Sydney Metro Martin Place

Over Station Development

Design Review Panel #08

25 February 2019

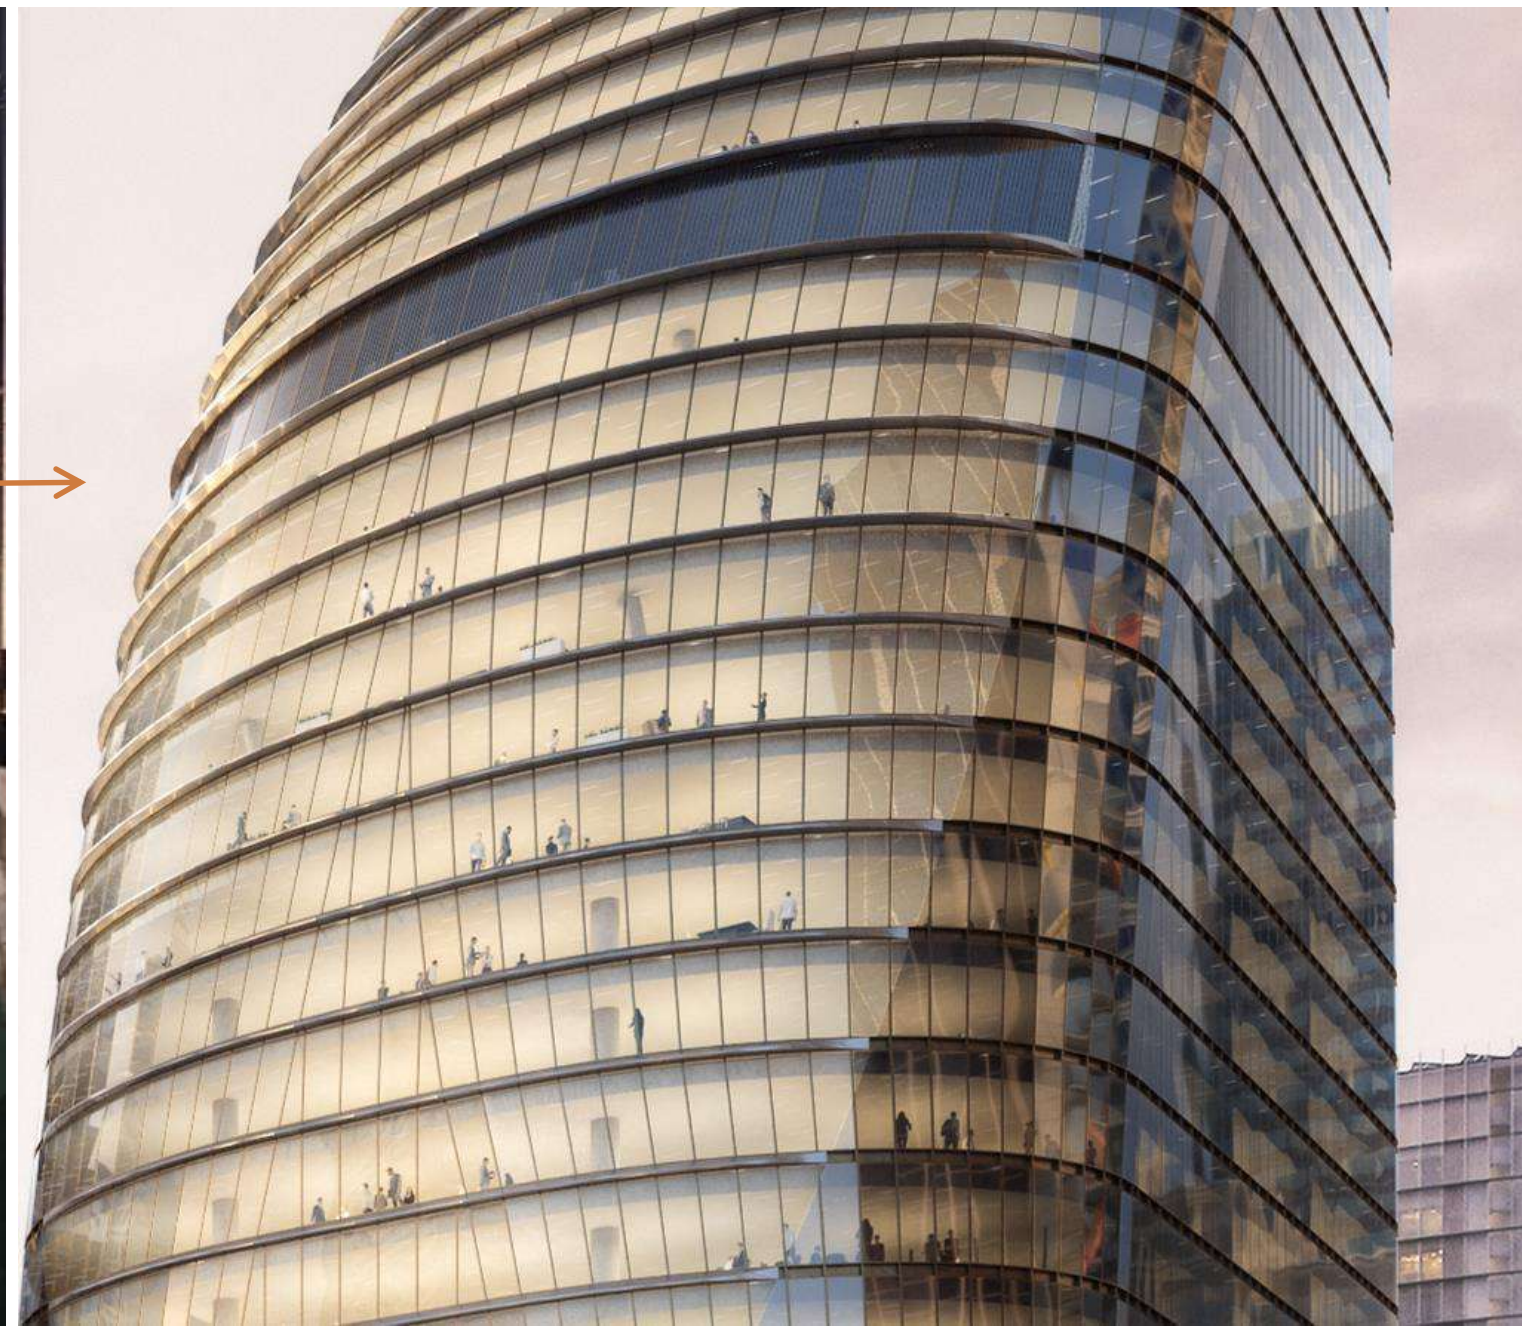
4. Through site link

DRP comment *a more decisive approach is required to provide a fully open and publicly accessible space. It is crucially important that if this is to be a public room, that details and materials reflect this approach, and that any commercial signage or branding doesn't detract from the public nature and feel of this space*

Open Items

- *Exploration of extension of masonry elements from outside to in to reflect public character of the through-site link*
- *Legibility, accessibility and public character of the through site link is not yet adequately resolved*
- *Further information relating to the intended character and operation of the space which should emphasise public connections*
- *Access to the through site link still seems overly constricted from Castlereagh Street – we strongly recommend further consideration be given to reducing the steepness of the stairway from Castlereagh Street*
- *Clear wayfinding logic to support the legibility of vertical and horizontal circulation between the through site link and the Hunter Street entrance and the levels above and below.*

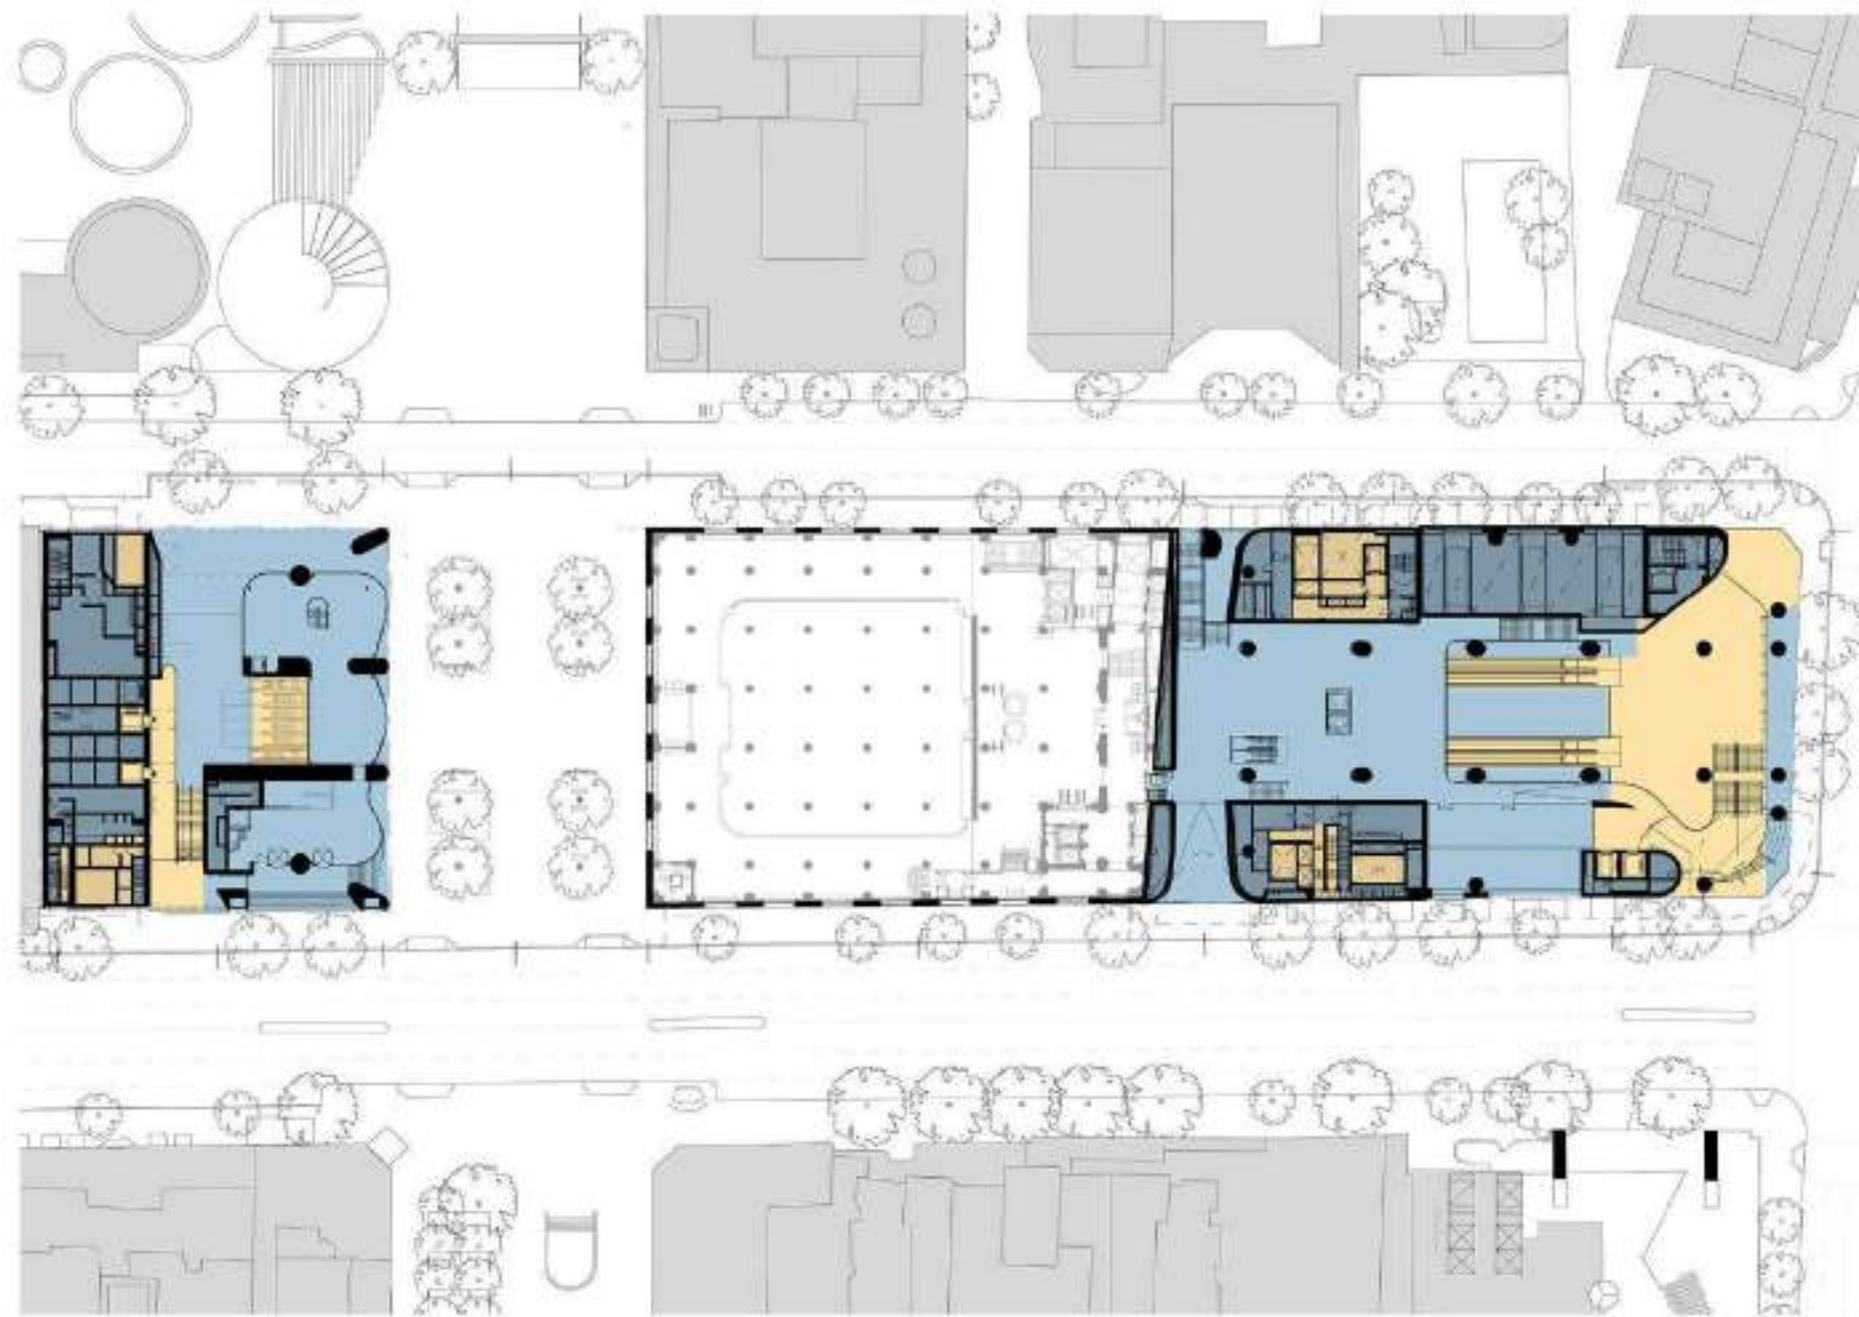
5. Artworks

DRP comment *we support the locations of the artworks, careful consideration should be given to the base materials in which they sit (or are mounted), particularly the Tom Bass fountain which we believe is unsuited to an anodised aluminium surround, and similarly the Douglas Annand bronze sculpture. We are also concerned about the proposed mounting height of both these artworks, noting that the sculpture was originally mounted at a height of approximately 3 metres above an entrance doorway.*

We note the need for gates to secure the through-site link after hours, however these must not conflict with the reinstated artworks

Open Items

- *Exploration of materials that are compatible with the calibre of the reinstated artworks*
- *Exploration of the height of the Tom Bass fountain and Douglas Annand bronze sculpture to reflect historic placement and enhance viewer experience*
- *Confirmation that the security gate off Elizabeth Street is located at the innermost end of the entrance*
